HISTORIC AND DESIGN REVIEW COMMISSION

HDRC CASE NO: 2022-424
ADDRESS: 322 N HACKBERRY ST
LEGAL DESCRIPTION: NCB 584 BLK W 1-2 7 LOT W 108.33 FT OF 6 ARB A8
ZONING: RM-4, H
CITY COUNCIL DIST.: 2
DISTRICT: Dignowity Hill Historic District
APPLICANT: Noe Garcia/GARCIA MAGDALENA L & NOE A
OWNER: Noe Garcia/GARCIA MAGDALENA L & NOE A
TYPE OF WORK: Construction of a carport and rear accessory structure, exterior modifications, fenestration modifications
APPLICATION RECEIVED: August 04, 2022
60-DAY REVIEW: Not applicable due to City Council Emergency Orders
CASE MANAGER: Edward Hall

Historic and Design Review Commission
Design Review Committee Report

HDRC Case #: 2022-424

PROPOSED SITE PLAN
NEW CARPORT, STORAGE
SHED AND STAIRS
322 N. HACKBERRY, SAN ANTONIO, TEXAS

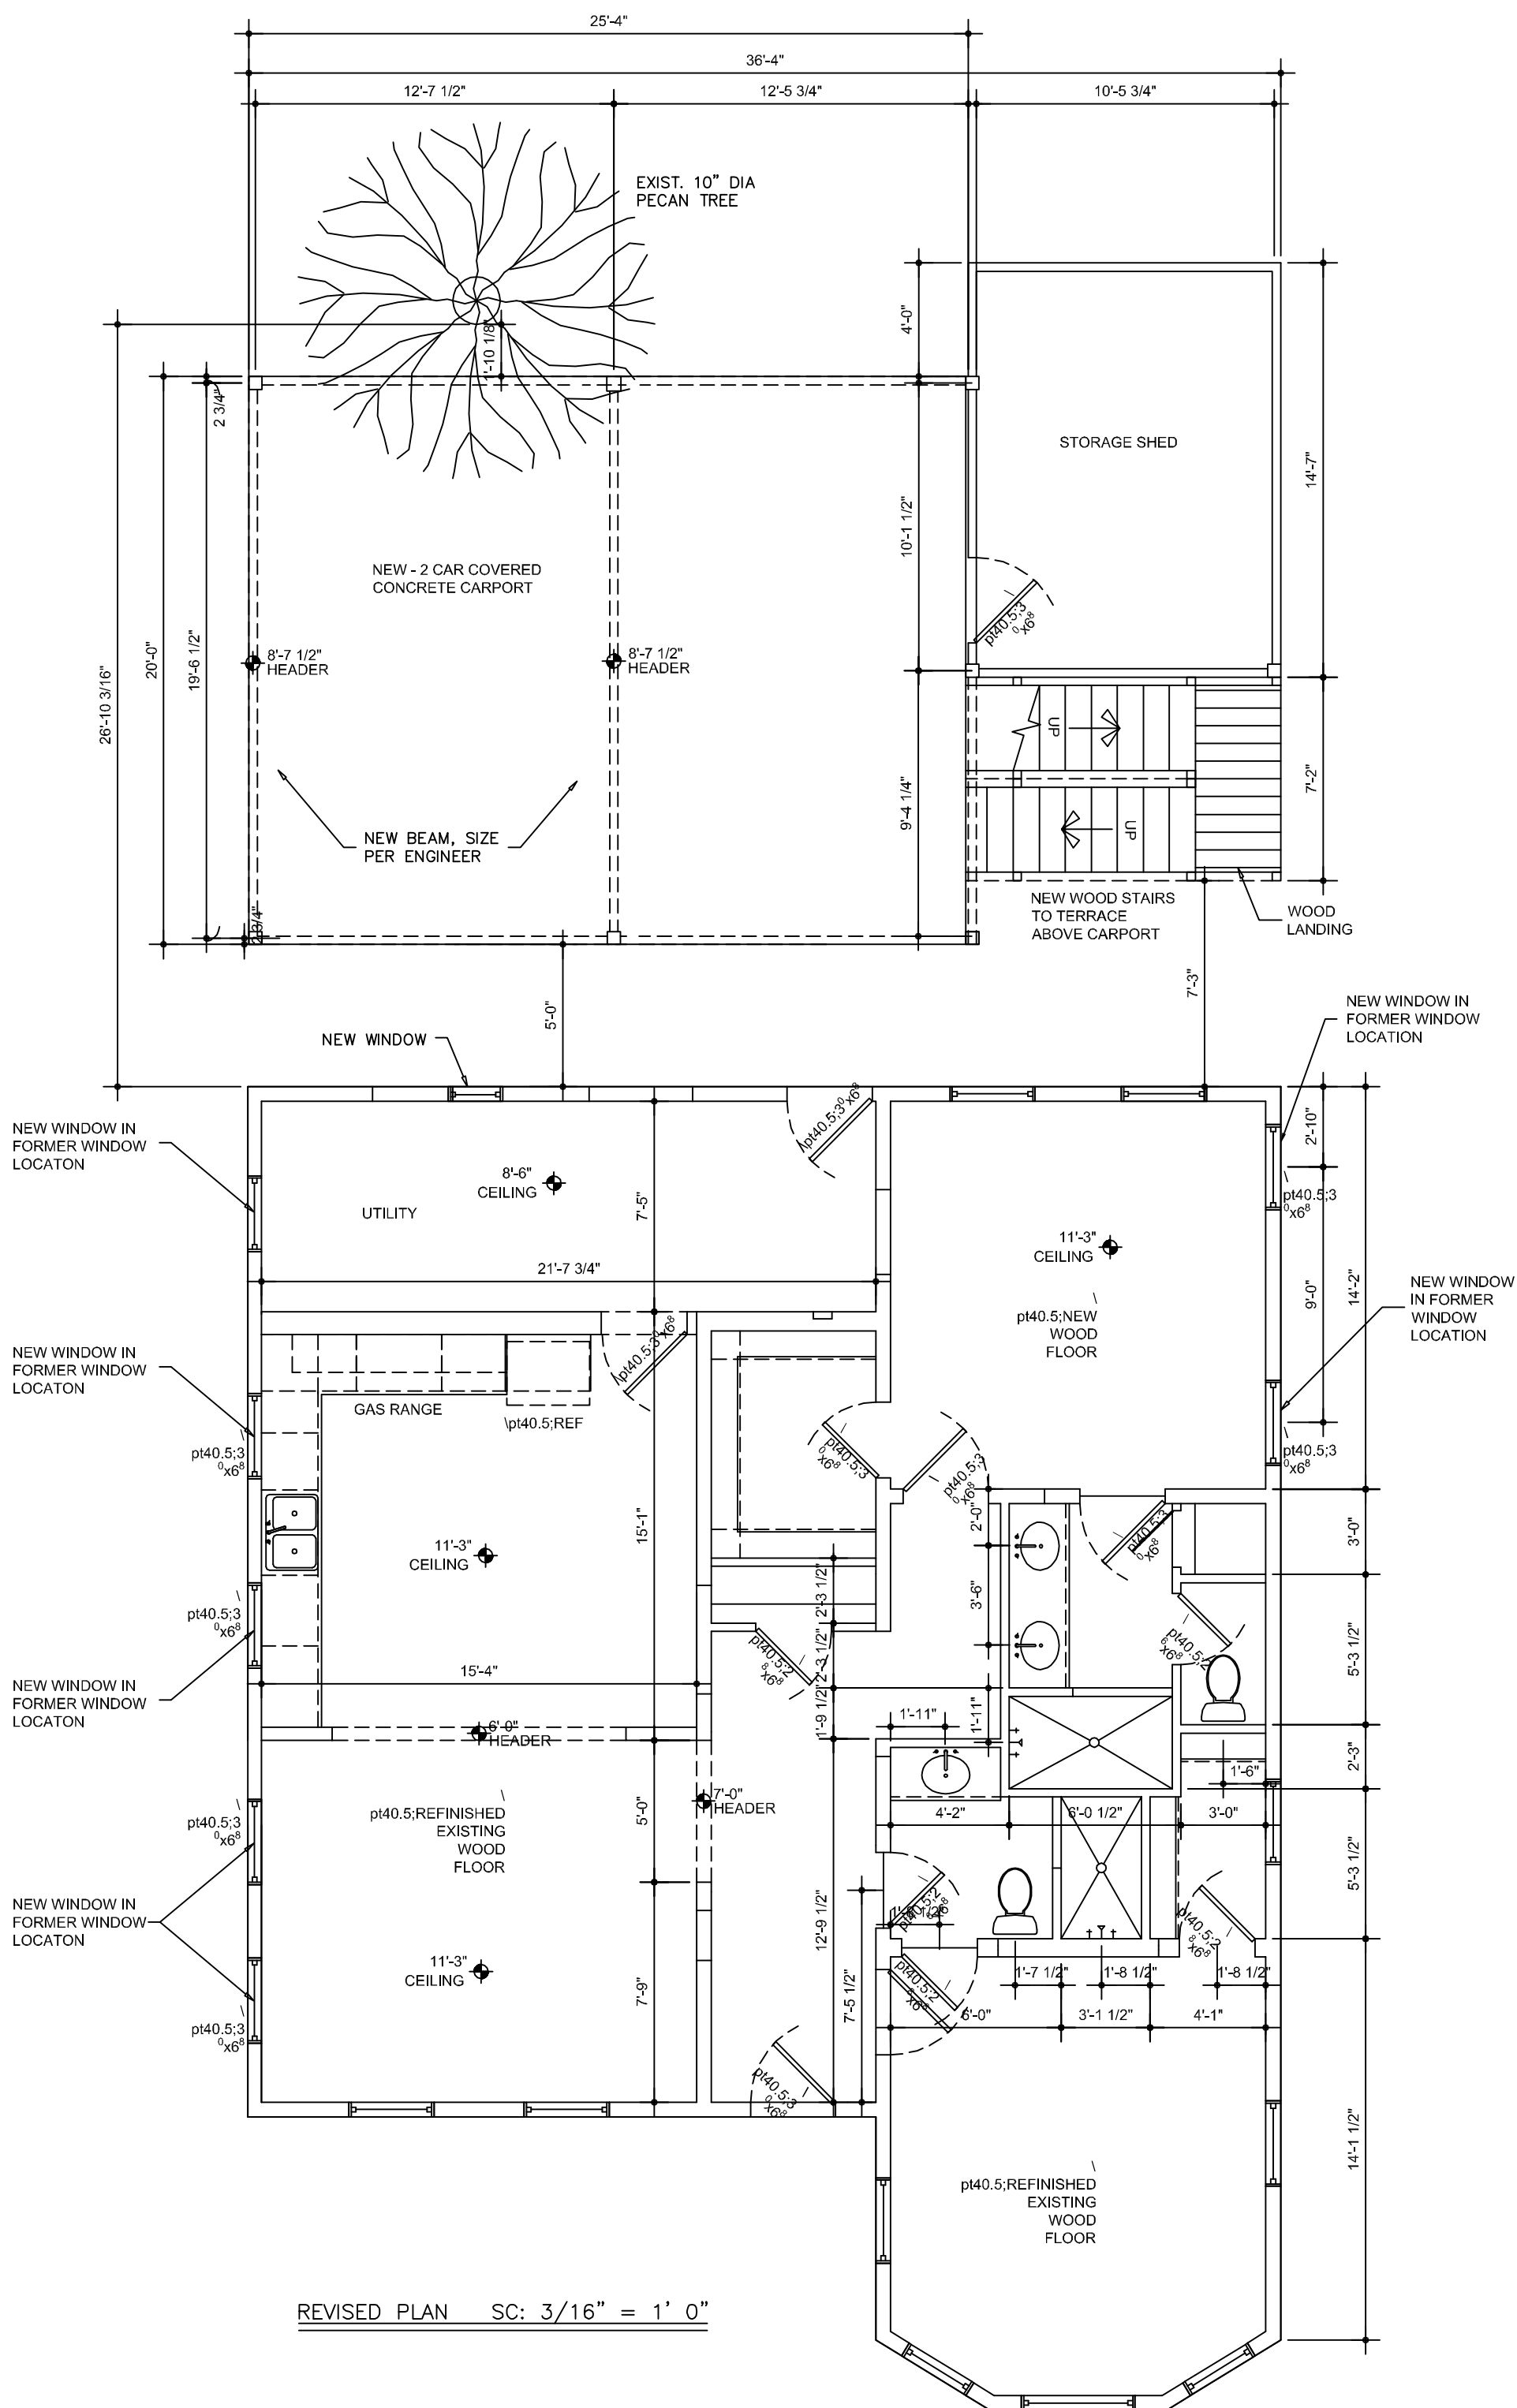
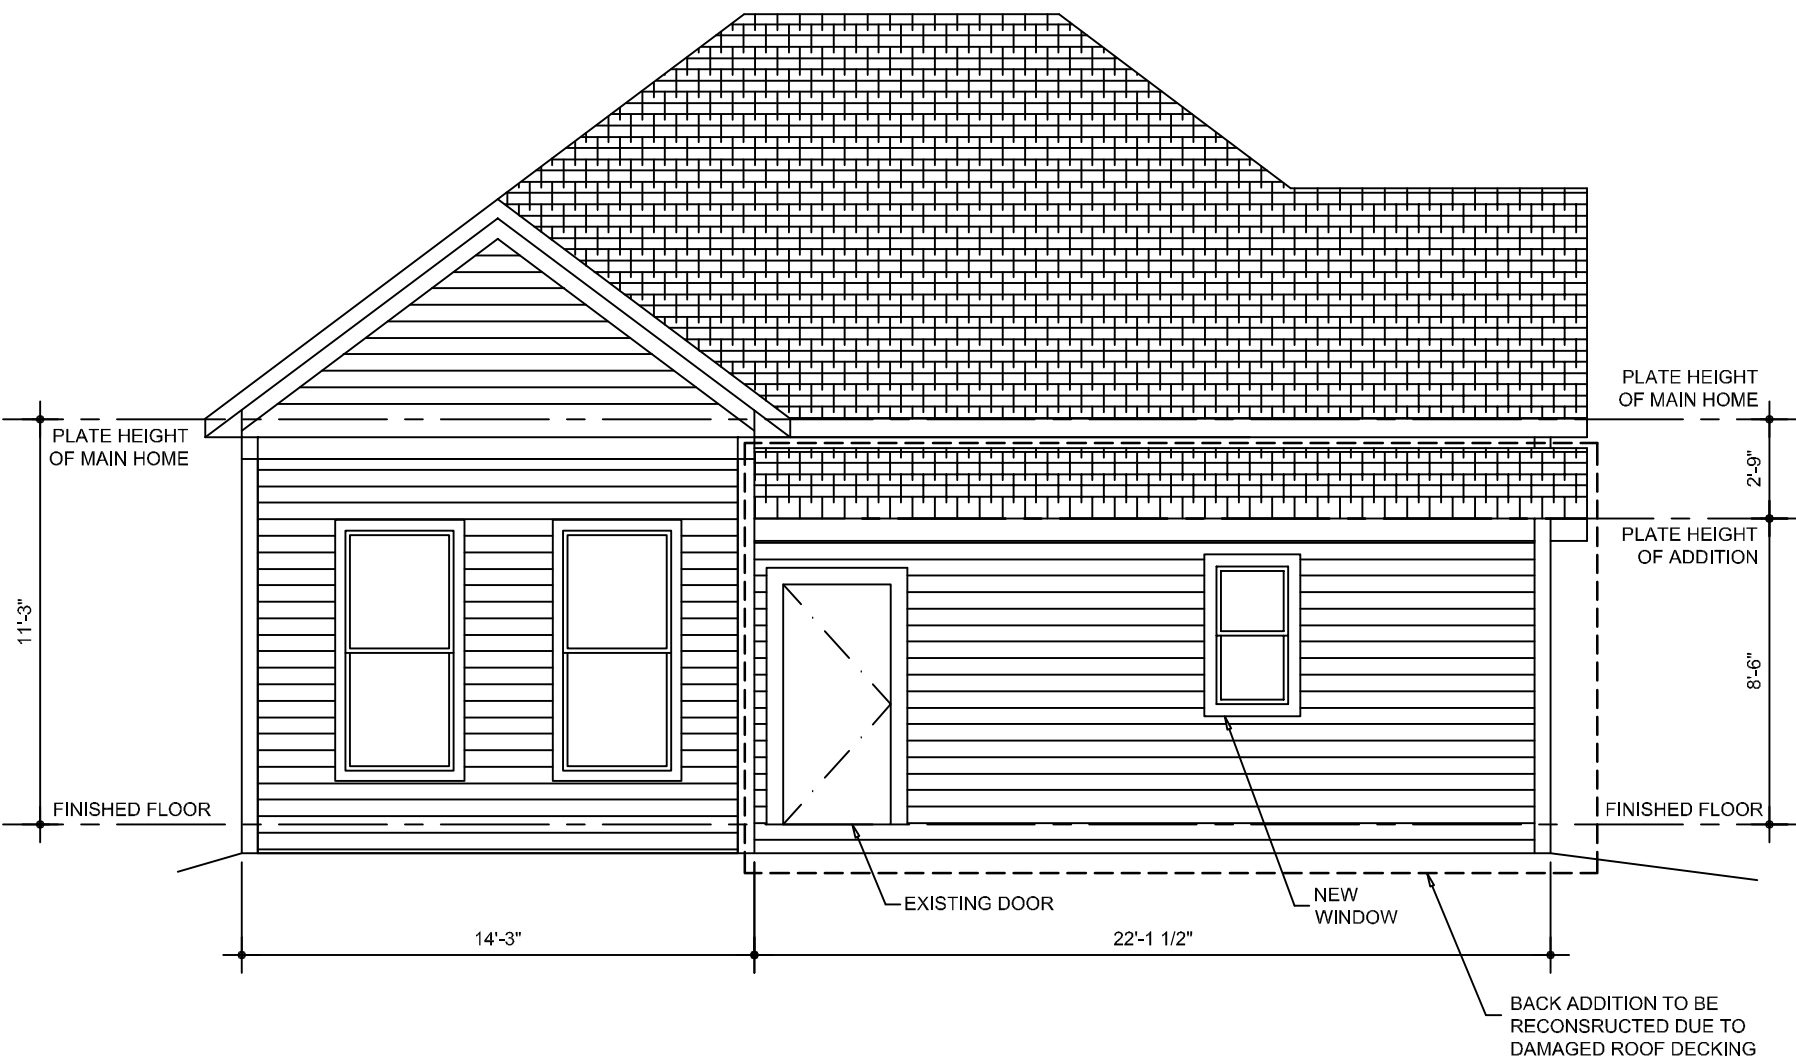
- e. **MASSING & FORM** – The Guidelines for New Construction 5.A. notes that rear accessory structures are to feature a massing and form that is visually subordinate that that of the primary historic structure in regards to their height, massing and form, should be no larger in plan than forty (40) percent of the primary historic structure's footprint and should relate to the period of construction of the primary historic structure. The applicant has proposed a total of approximately 740 square feet, including the carport, enclosed storage space and exterior stairs. The primary, historic structure on site features a footprint of 1,428 square feet. The proposed footprint is approximately fifty-two (52) percent of the primary structure's footprint. The enclosed storage

structure features a footprint of approximately 153 square feet. Staff finds a reduction in footprint would be most appropriate. A reduction in footprint from the north (N Hackberry) side of the structure would also provide an increased setback.

- g. **ORIENTATION & SETBACK** – The Guidelines for New Construction 5.B. notes that the predominant garage orientation and historic setback patterns of the block should be followed. Generally, staff finds the proposed location and orientation of the proposed new construction to be appropriate; however, as noted in finding d, staff finds that the proposed carport structure should feature a greater setback from N Hackberry. This would allow for the structure to feature a greater setback on N Hackberry than the primary historic structure and would also reduce the footprint to bring the structure into consistency with the Guidelines, as noted in finding e.

- h. **CHARACTER** – The applicant has proposed wood framing, wood siding and trim, a shed roof and wire cable railing. Generally, staff finds the proposed materials and character of the rear structure to be appropriate. Staff finds that wood framing with wire cabled would be more appropriate for the proposed railing than metal framing. The proposed door should be wood, to be consistent with those found historically on site.

- i. **DRIVEWAY** – The applicant has proposed to install a new concrete driveway at the rear of the lot to feature an increased width of twenty (20) feet. The Guidelines for Site Elements 5. B. notes that driveways should feature materials, widths, and designs that are consistent with those found historically within the district. The Guidelines also note that driveways should not exceed ten (10) feet in width. Staff finds the proposed driveway modification to be inconsistent with the Guidelines. Increased on site paving may be appropriate provided it is set within the property line and does not impact the existing curb cut, driveway apron and approach.

- i. That the applicant reduce the overall proposed footprint to be consistent with the Guidelines, as noted in finding e.
 - ii. That the applicant increase the setback (N Hackberry) to be greater than the side setback of the historic structure on the lot.

- iii. That wood framing with wire cables be installed rather than railing with metal framing.
 - iv. That the proposed door be wood, to be consistent with those found historically on site.

- 3. Staff does not recommend approval of item #3, the installation of a driveway featuring a width of twenty (20) feet, as noted in finding i. Increased on site paving may be appropriate provided it is set within the property line and does not impact the existing curb cut, driveway apron and approach.

MAIN HOME EAST ELEVATION SC: 3/16" = 1' 0"

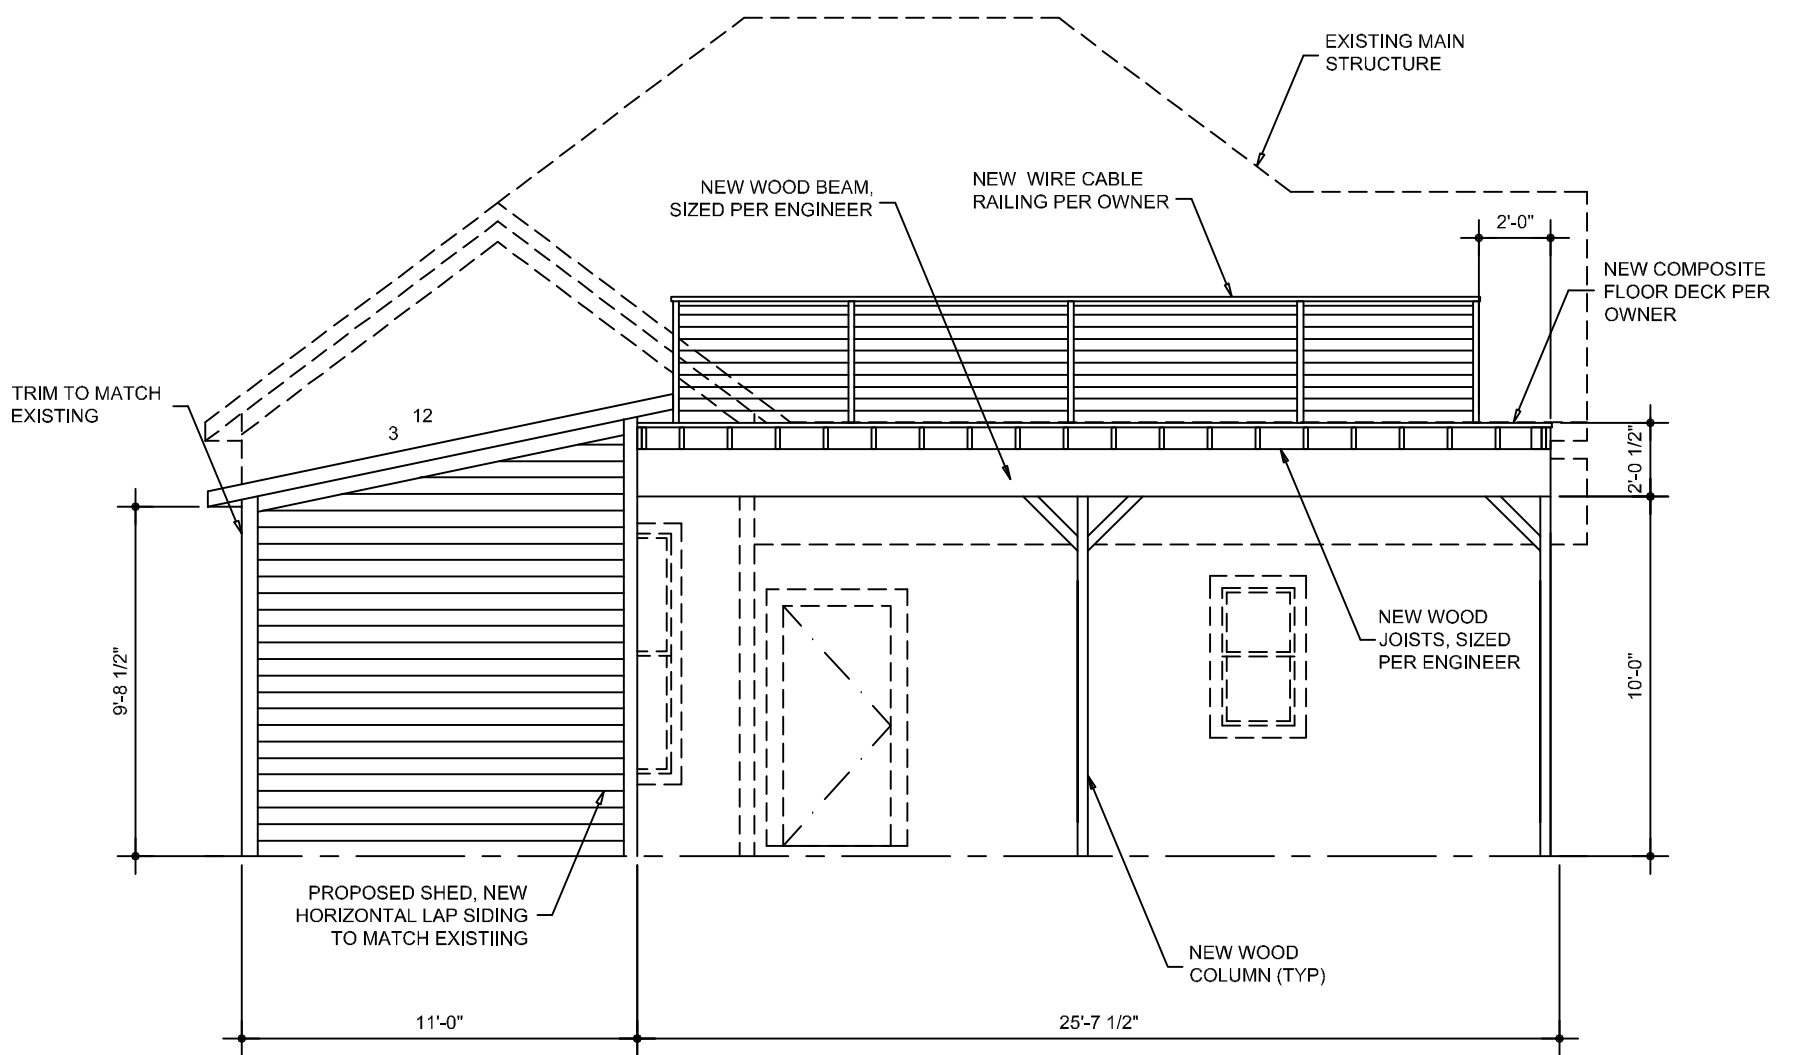
- k. **FENESTRATION MODIFICATION (Rear, east façade)** – The applicant has proposed to modify the fenestration on the existing, non-original rear façade at the location of a previously enclosed porch. The applicant has proposed for the new façade to feature one door and one, one over one window opening. Staff finds the proposed rear elevation to be appropriate. Staff finds that the proposed rear door and windows should be consistent with the Guidelines and staff’s standards for replacement windows.

- l. **REAR PORCH ROOF MODIFICATION** – The applicant has noted water damage to the existing, rear porch roof. The applicant has proposed to repair the roof structure, and in the course of doing so, raise the overall top plate and roof height slightly. The proposed pitch will remain as it is, and the roof will remain below the fascia of the primary roof form. Generally, staff finds this proposal to be appropriate.

5. Staff recommends approval of item #5, the modifications to the fenestration on the existing, non-original rear façade at the location of a previously enclosed porch based on finding k with the following stipulation:
 - i. That the proposed rear door and windows should be consistent with the Guidelines and staff's standards for replacement windows.
6. Staff recommends approval of item #6, the reconstruction of the rear shed roof and slight raise of the overall roof height, as submitted, as noted in finding l.
